RIO  
2|00

PHASE V

BUILDING - 58 SOUTH RIVER DRIVE | TEMPE, AZ 85281

# 8'0" TENANT D/S MONUMENT SIGN PANEL - Monument Size Option A

SECOND FLOOR

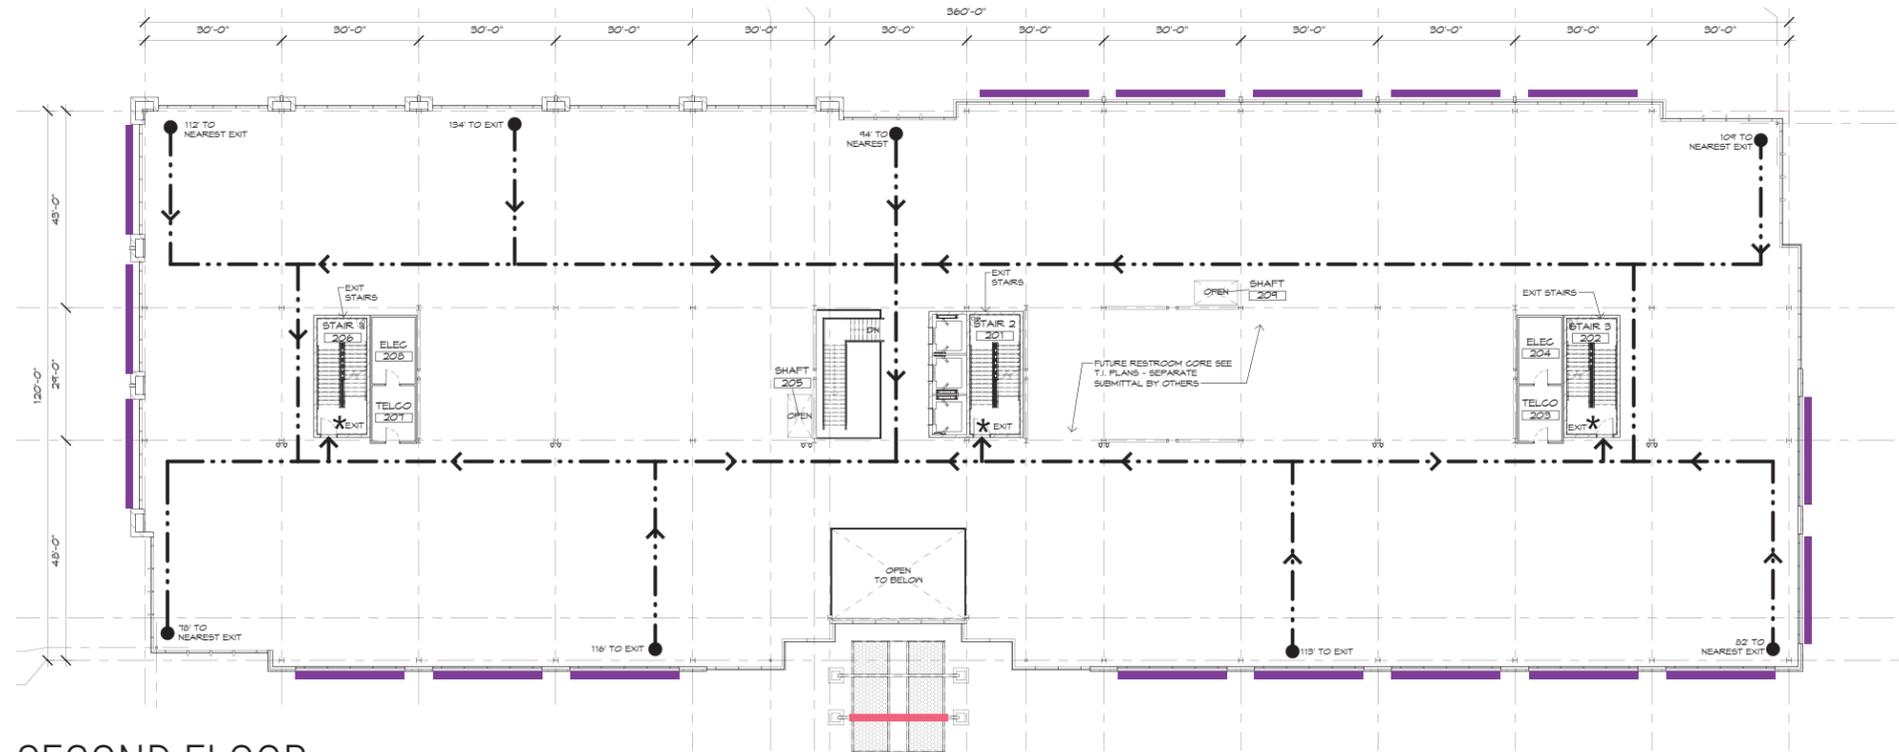
Too many proposed sign locations.

# TENANT SIGN - WALL MOUNTED

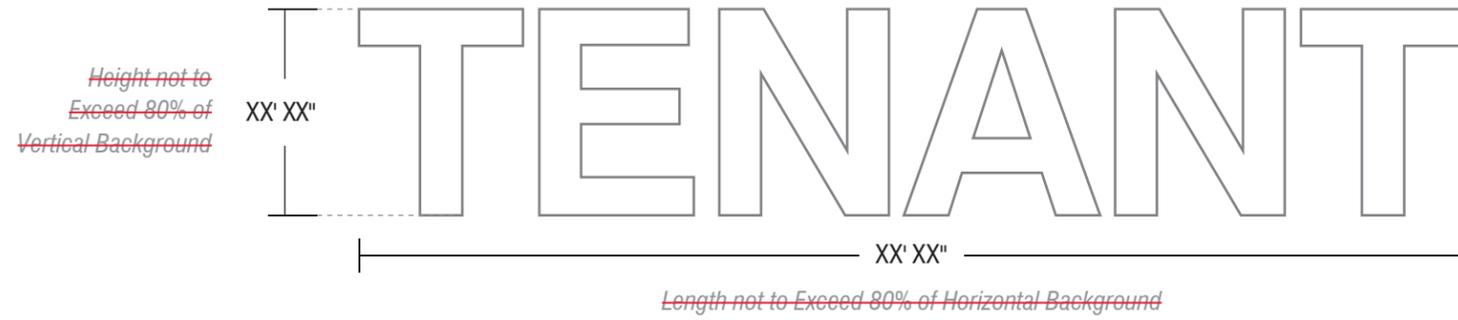
Provide building details

Provide true elevation details with measurements identifying the background areas for the signs. This will help us identify appropriate sign envelope locations and sizes.

Remove these signs from the proposal as they do not truly represent the building.

# TENANT SIGN - UPRIGHT MOUNTED

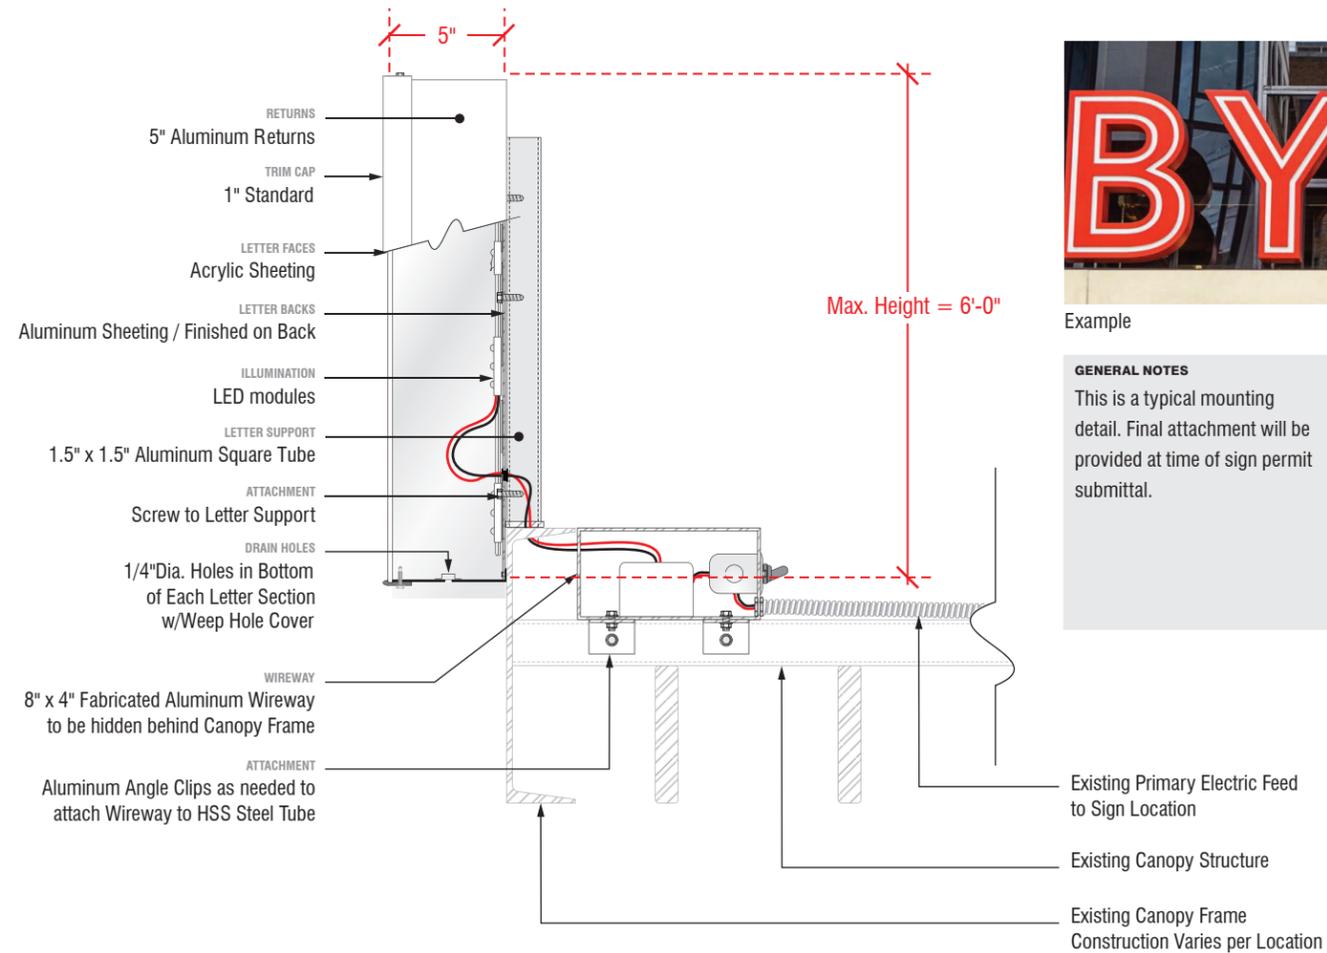
- Upright Mounted Signs may be attached upright-mounted on a designated horizontal surface. **What surface? Show us true elevations with details. Nothing above the roof line**

- Sign area is determined as per the requirements outlined in the General Provisions section of this chapter per Tempe Sign Code.
- Upright Mounted Signs should appear to be seamlessly integrated into the canopy by extending the fascia to conceal electrical boxes, mounting, and wires (where structurally feasible). It is preferred that letters and logos be mounted directly to the electrical box or fascia to avoid exposed raceways. When an extended fascia is not present, electrical boxes and mountings shall be low profile and limit exposed raceways, and colors shall match the mounting surface to be less conspicuous. **One line of copy only**

**Provide true elevation details with measurements identifying the background areas for the signs. This will help us identify appropriate sign envelope sizes.**

**Remove these signs from the proposal as they do not truly represent the building.**

# TENANT SIGN - UPRIGHT MOUNTED

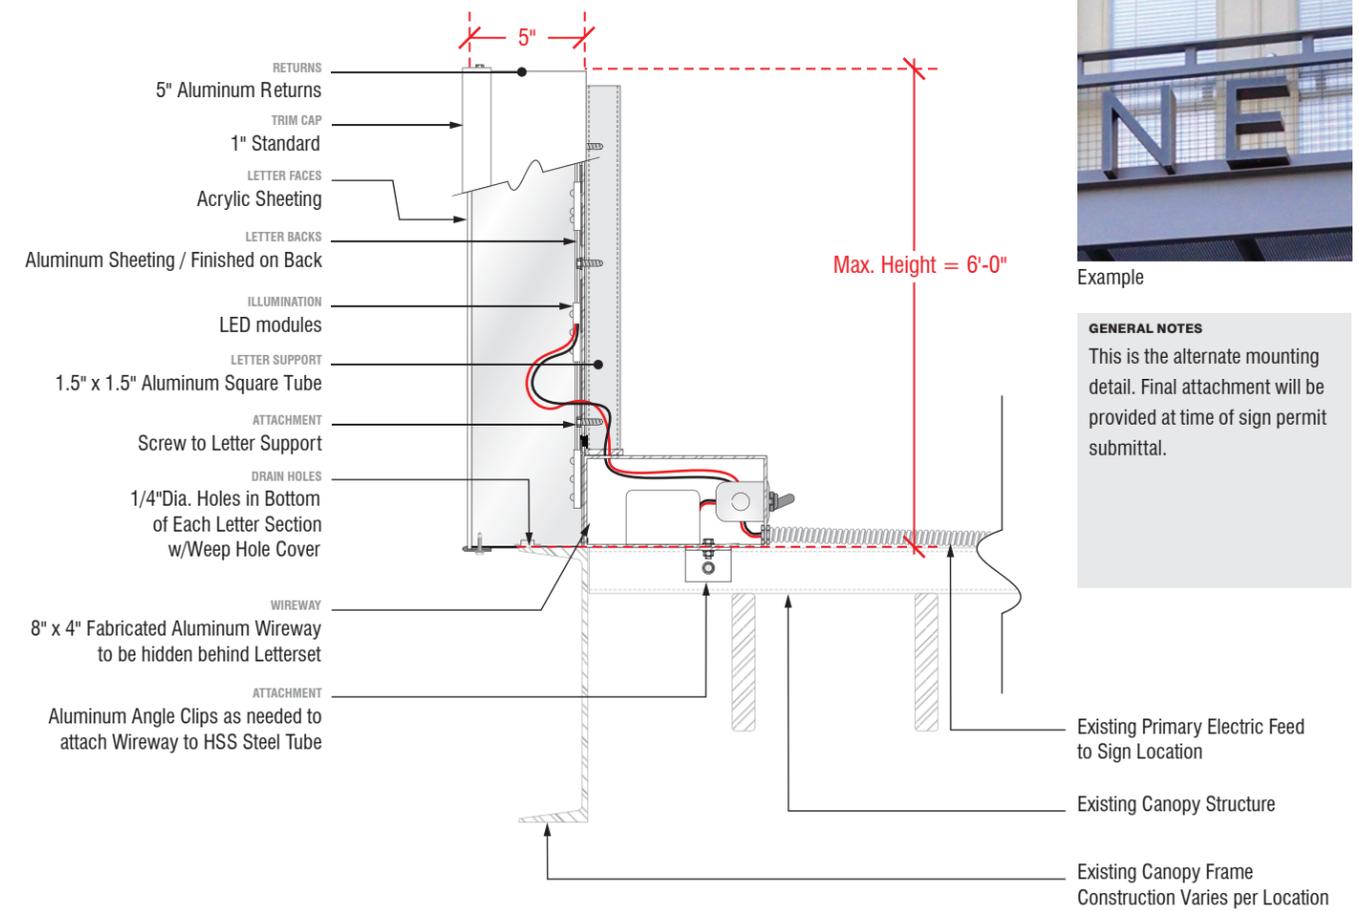
There are too many proposed sign locations. Tenants that occupy a minimum of an entire floor will be allowed signs on the building. A maximum 2 signs allowed for the west and east elevations only. Provide true elevation details with measurements identifying the background areas for the signs. This will help us identify appropriate sign envelope locations and sizes.

# SIGN BANDS

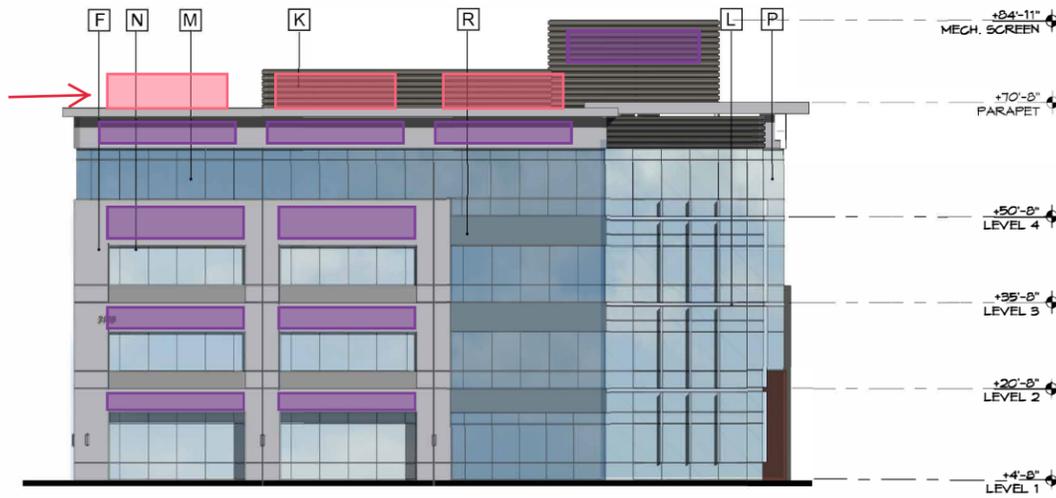
Nothing above the roofline
